F-M-0672(1)/64242  
OLD STEESE HIGHWAY  
RECONSTRUCTION

**AS-BUILT PLANS**

"I certify that revisions to these plans made during construction are noted in RED and therefore the plans are an accurate record of construction."

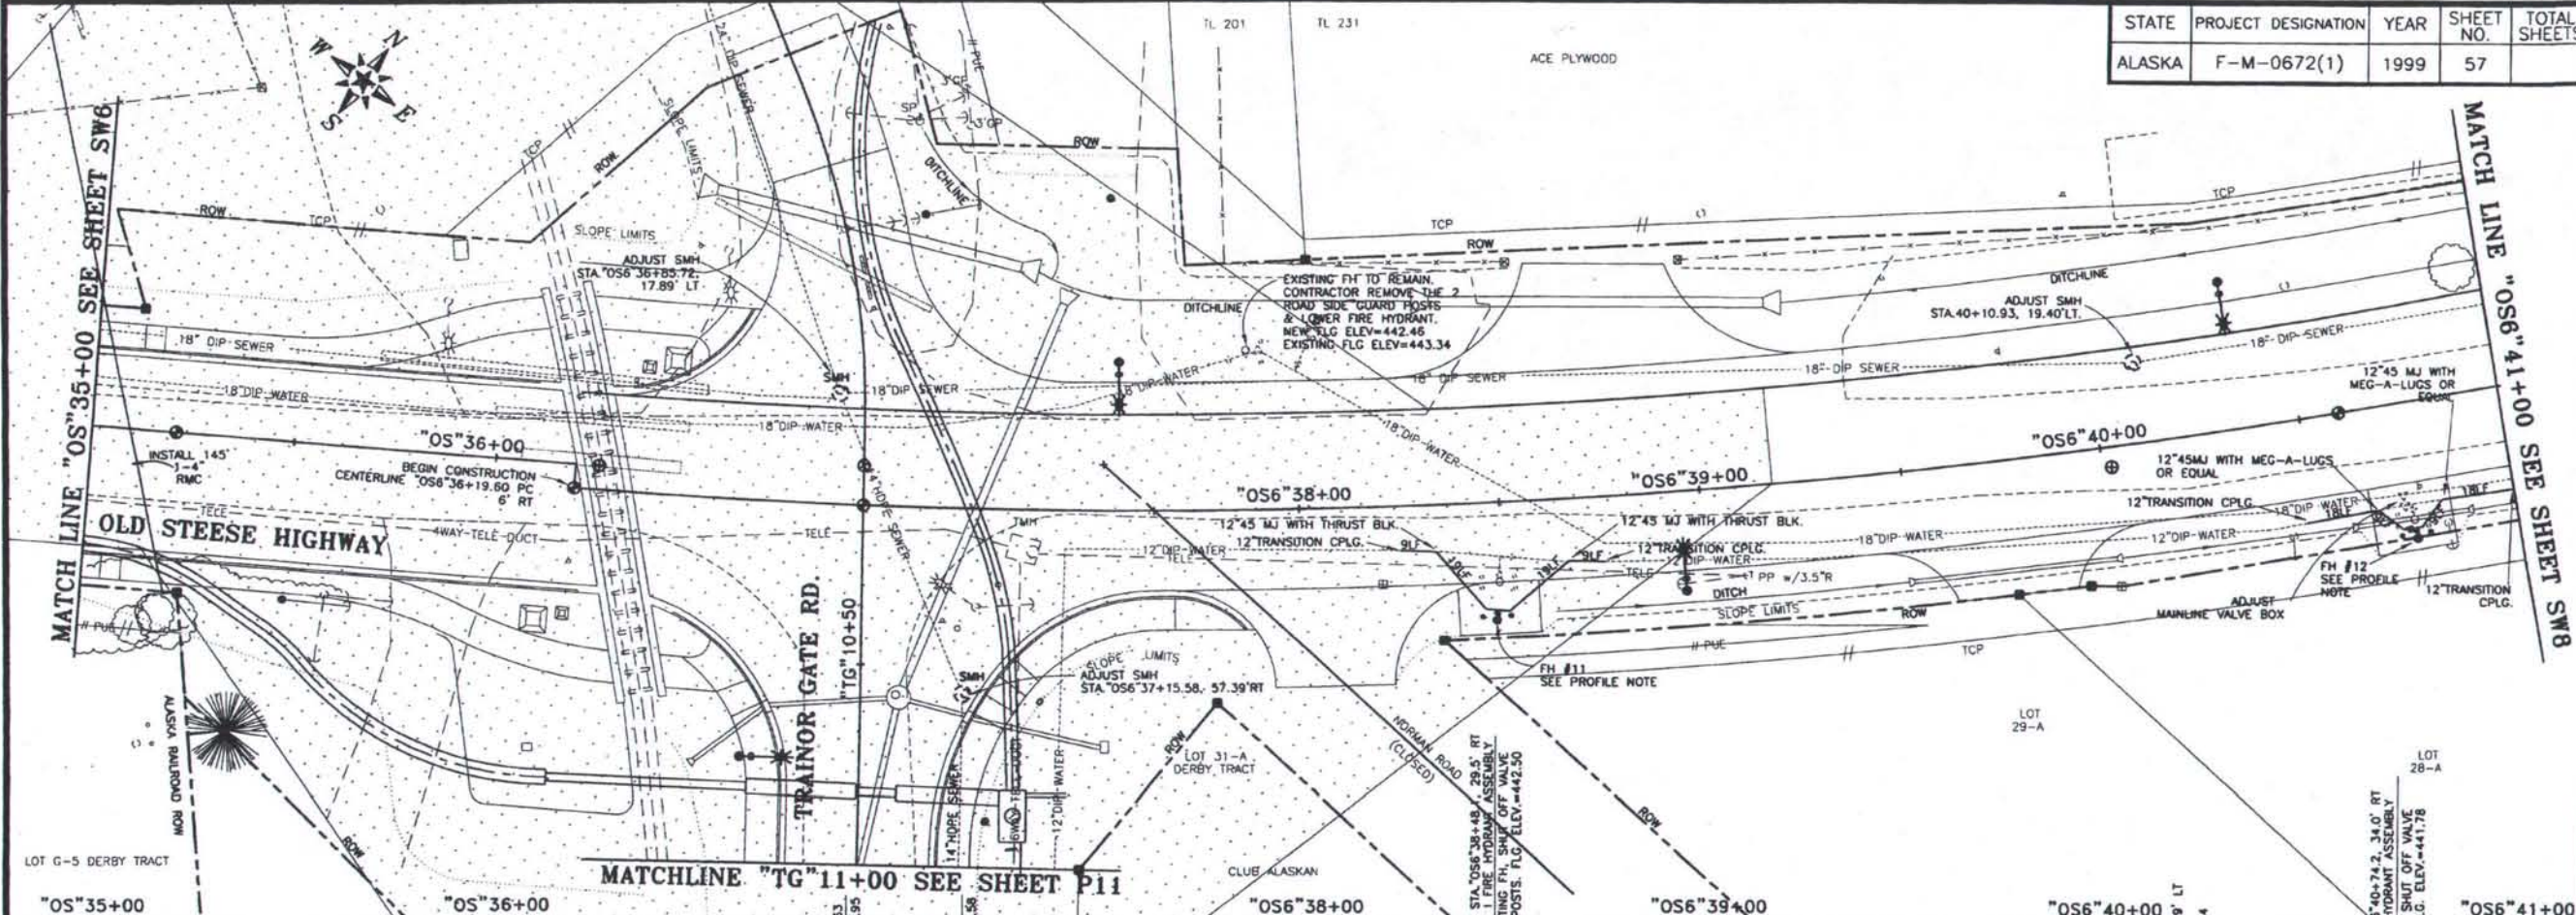
NOTE:  
 RECONSTRUCT SMH  
 STA. OS6 47+86.54, 21.29' LT  
 REMOVE EXISTING CONE.  
 INSTALL NEW 2' MH SECTION AND  
 REPLACE EXISTING CONE. ADJUST GRADE  
 RINGS FOR FINAL LID ELEV.  
 NEW LID ELEV=440.17  
 EXISTING LID ELEV=438.5  
 SEE SHEET P9

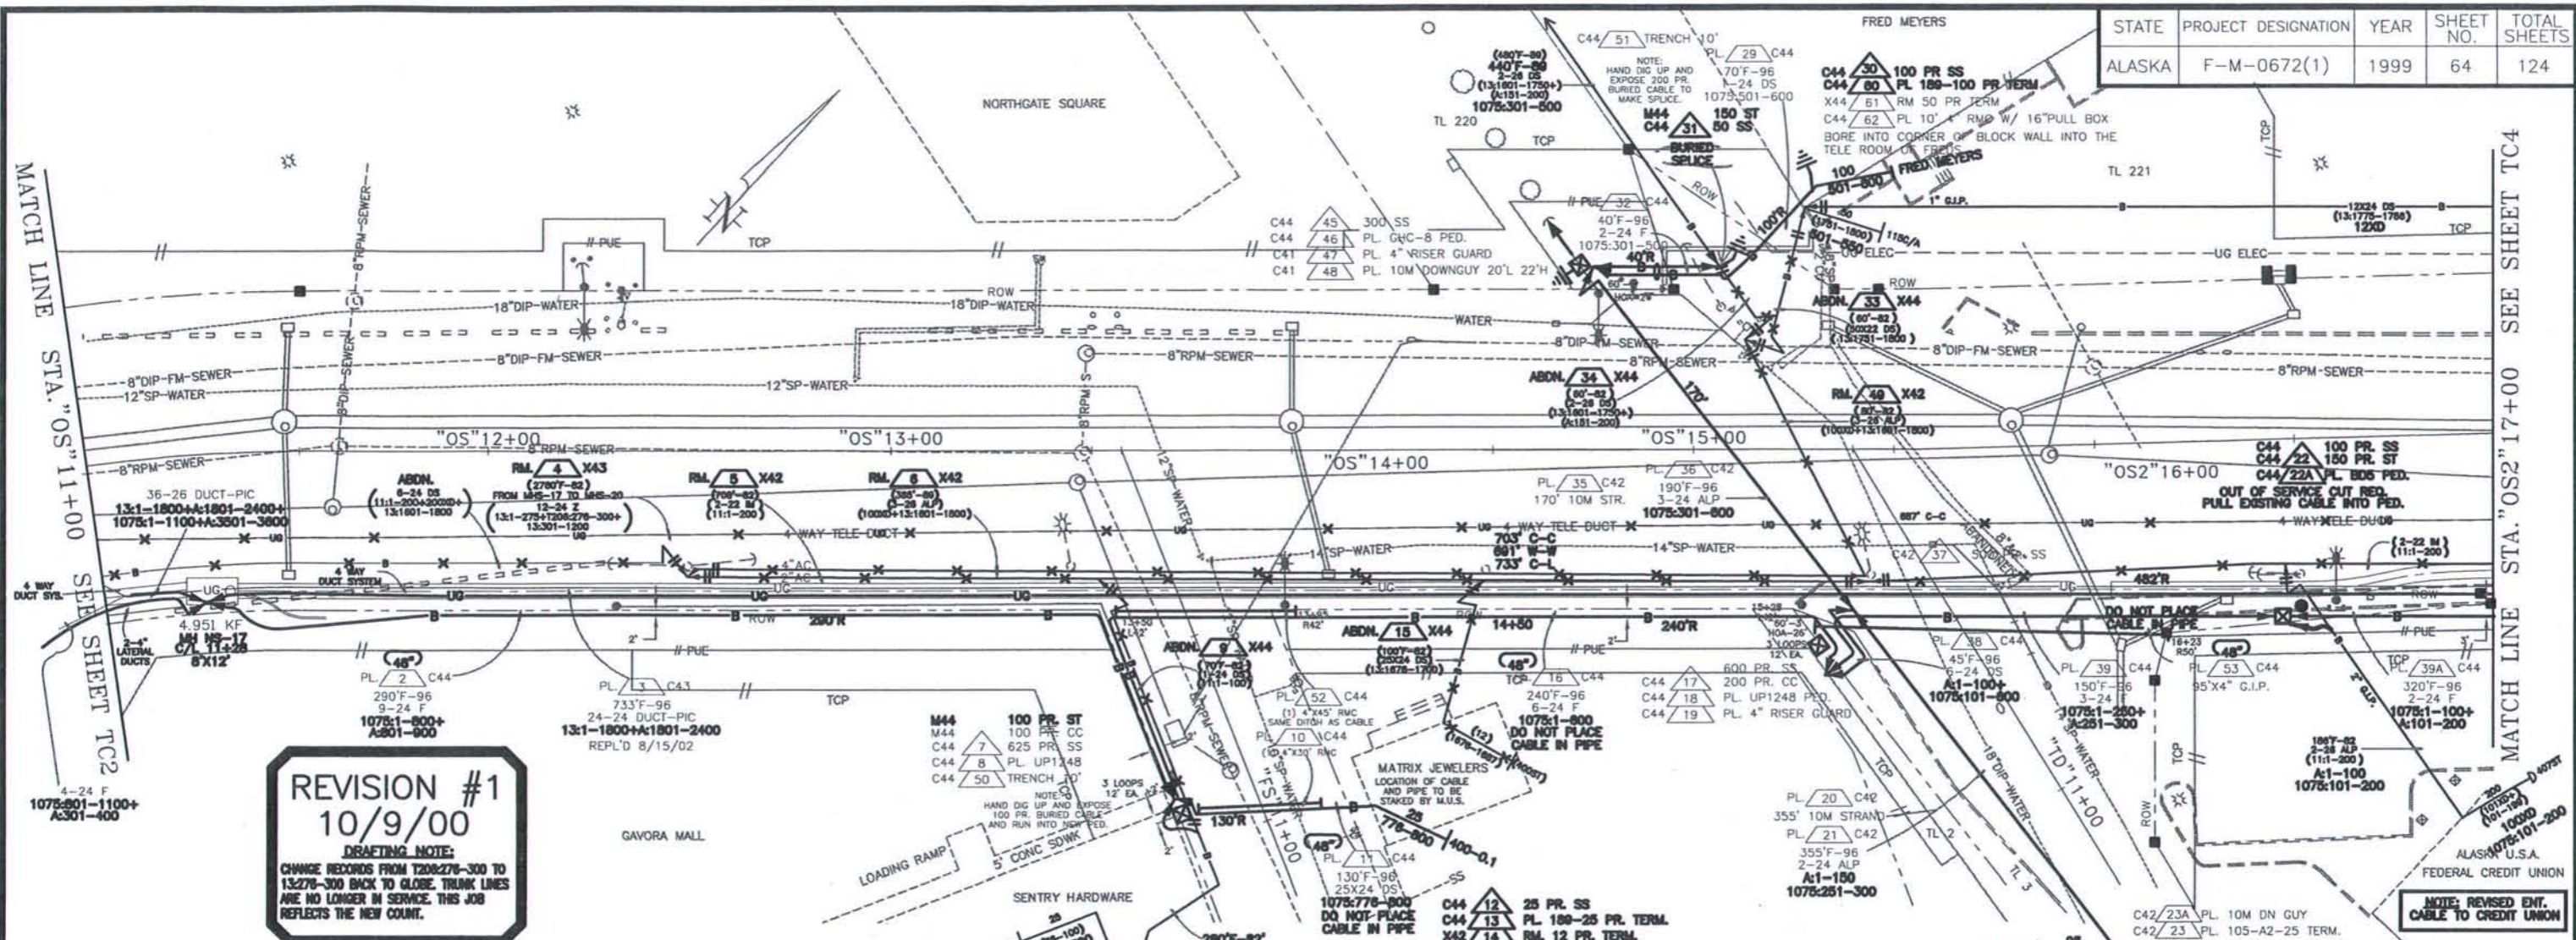
**REVISION #1**  
**10/9/00**  
 DRAFTING NOTE:  
 CHANGE RECORDS FROM T208276-300 TO 13276-300 BACK TO GLOBE. TRUNK LINES ARE NO LONGER IN SERVICE. THIS JOB REFLECTS THE NEW COUNT.
